Project Name: Replace Roofs (Program Phase 1 - 4)

Title: Roof Replacement - Phase 1 Facility B

RFI#: 007

RFI Description – Correctional Construction Mentorship Program (CCM)

ON JOINT DETAIL 1

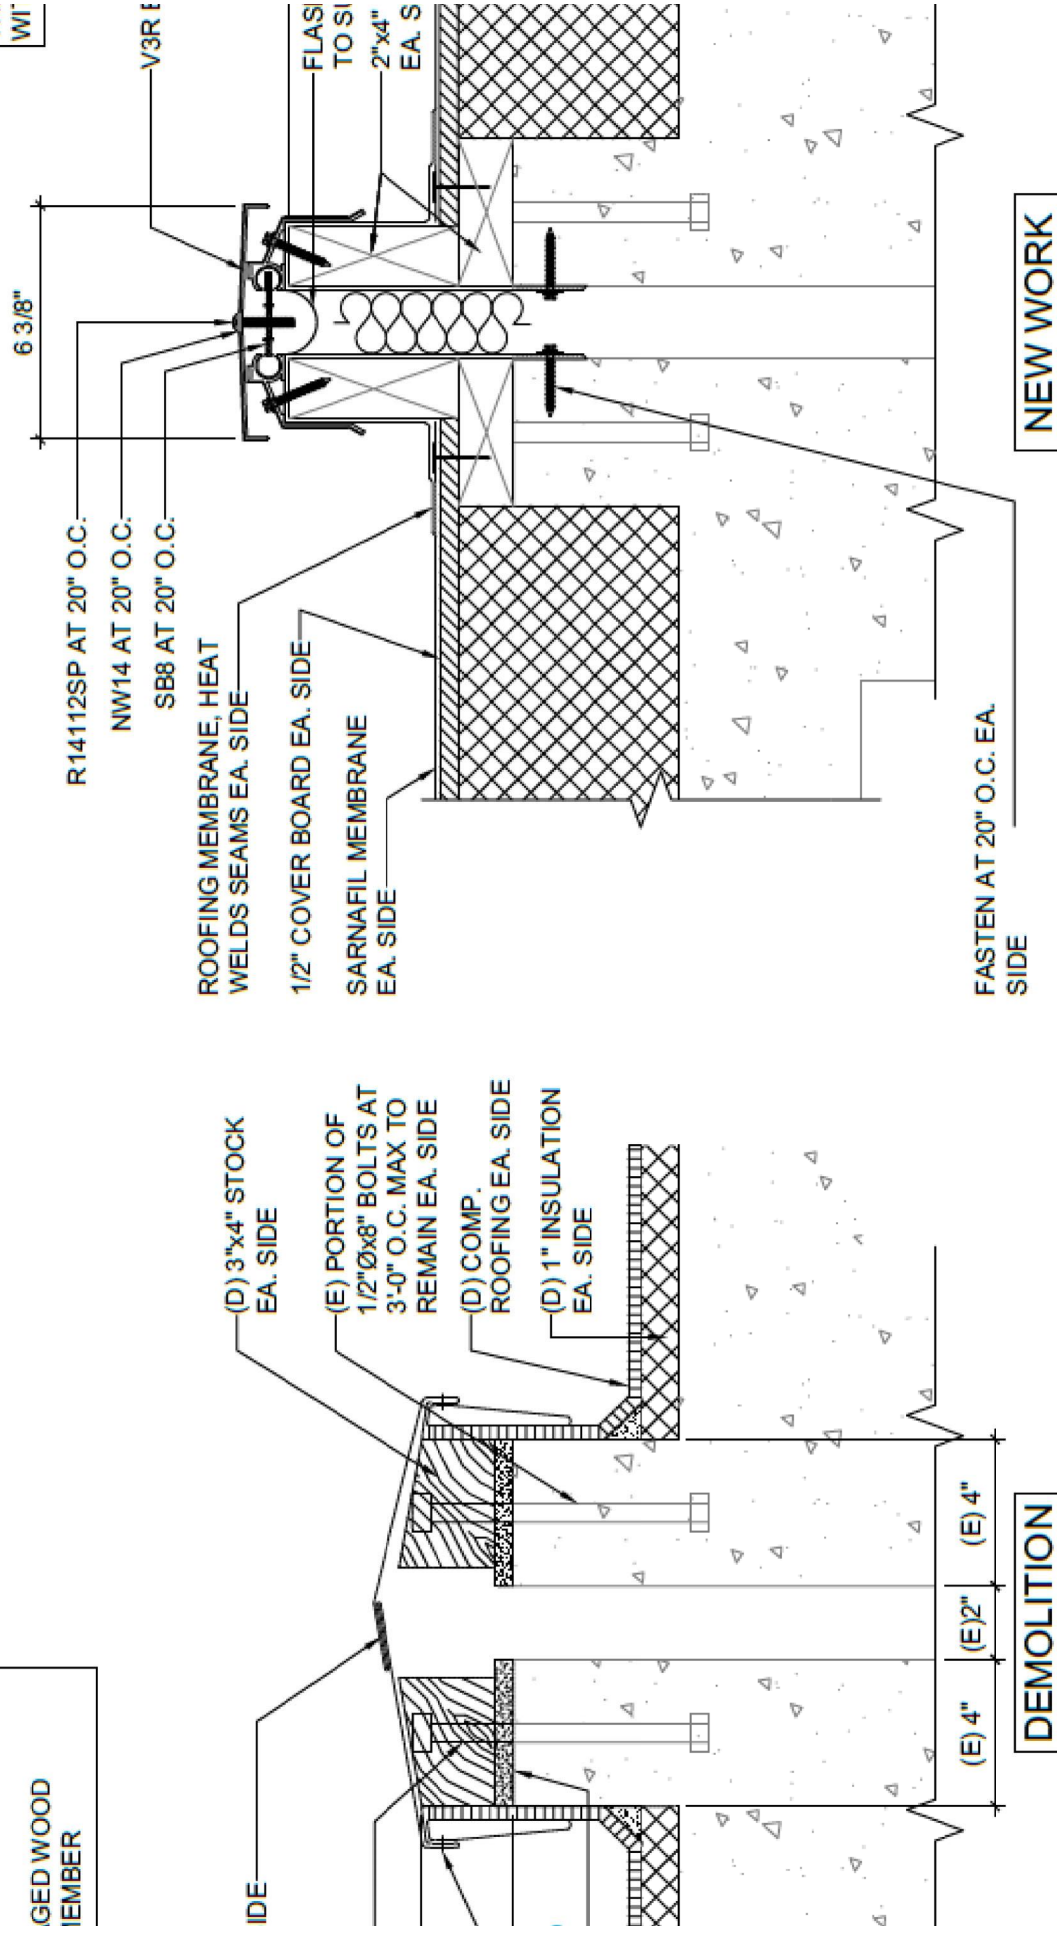
CCM is requesting verification of Fire Rating and Membrane Fasten location for expansion Joint, new construction Pg. A2.5 Detail 1 and A3.1 to use same detail for missing Detail 7-A3.1 Pg.A2.5. Special Condition 4 shows Detail 1-A3.1 for existing expansion joint with missing detail. See attached Plan Sheets.
Please Advise.

I concur with your comments. The fire rating requirements at the various expansion joints is unclear. The fasteners shown being installed inside the expansion joint gap could not be installed per the detail and this must be corrected. Detail(s) for expansion joints at vertical/wall locations need to be provided. The missing detail 7/A3.1 is in the process of being provided as part of RFI 004. I have contacted the consultant and asked them to make clarifications and corrections to their drawings. This will be issued in a forthcoming CB.

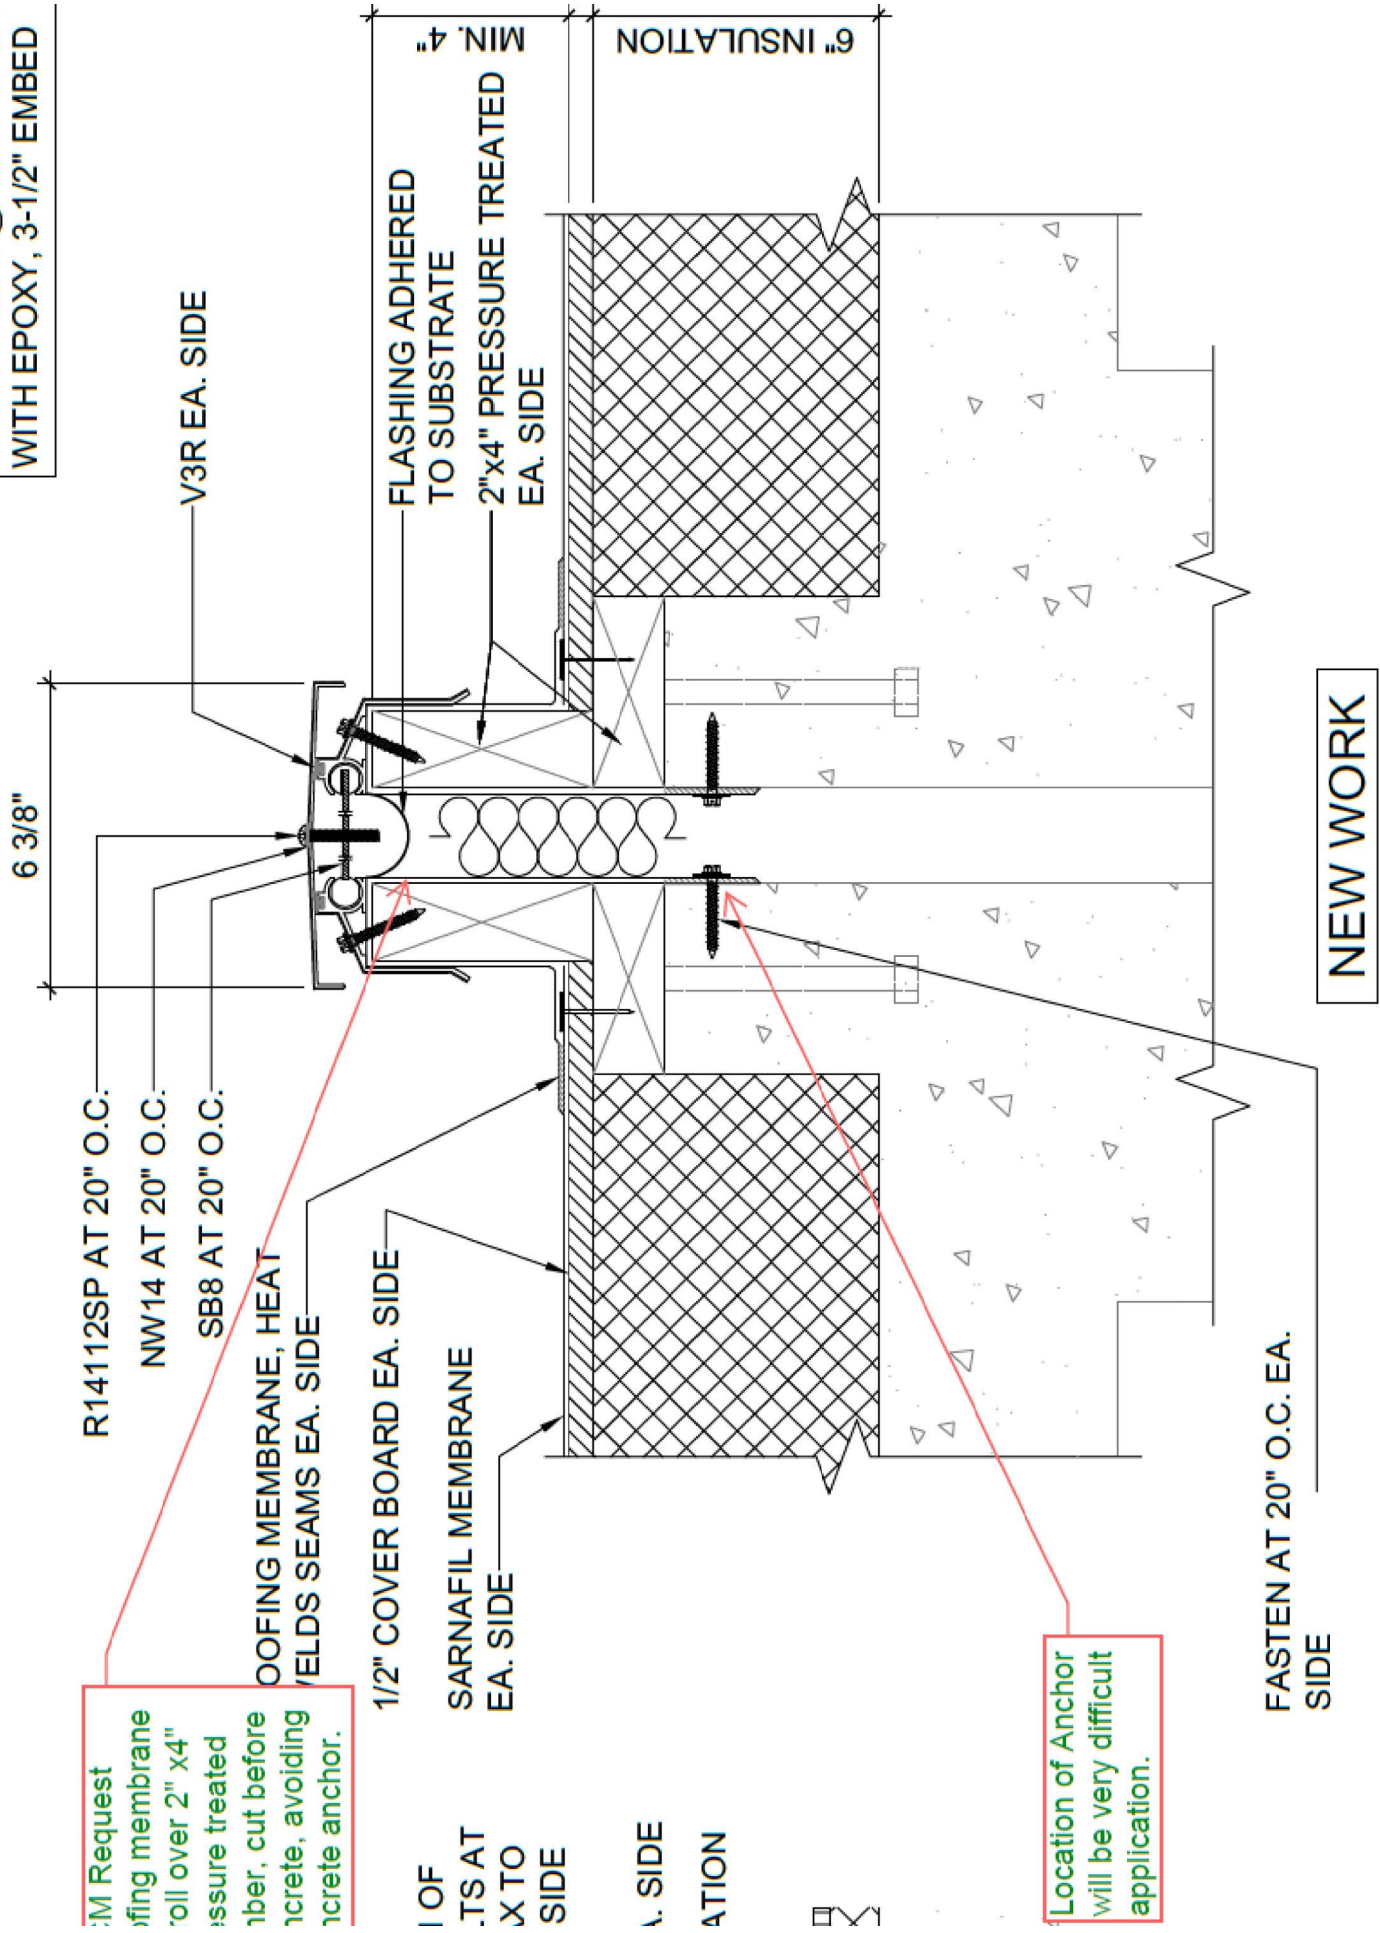
IM Request
 ing membrane
 roll over 2" x4"
 ssure treated
 ber, cut before
 crete, avoiding
 crete anchor.

Location of Anchor
 will be very difficult
 application.
